Proposal for the 04 series of amendments to Regulation No. 100 (Electric power trained vehicles) *

Submitted by the expert from the Netherlands

"Annex 10

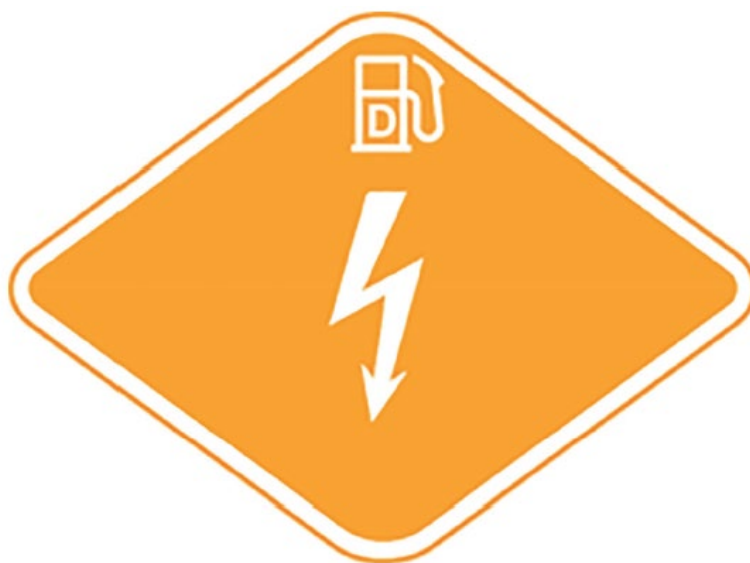
Provisions for a label for vehicles of categories M₂/N₂ and M₃/N₃ equipped with an electric power train.

(Paragraph 5.5.1 to 5.5.3. of this Regulation)

The label shall be weather resistant.

The centre zone indicates the first energy source.

The upper zone indicates the second energy source.

Layout and symbols shall be in accordance with ISO 17840-4:2018.

The colour and dimensions of the label shall fulfil the following requirements:

Colours:

Background:	Orange, RGB code 255, 165, 0
Border:	white reflecting
Letters:	white reflecting

Dimensions:

Sticker width:	≥ 110 mm
Sticker height:	≥ 80 mm"
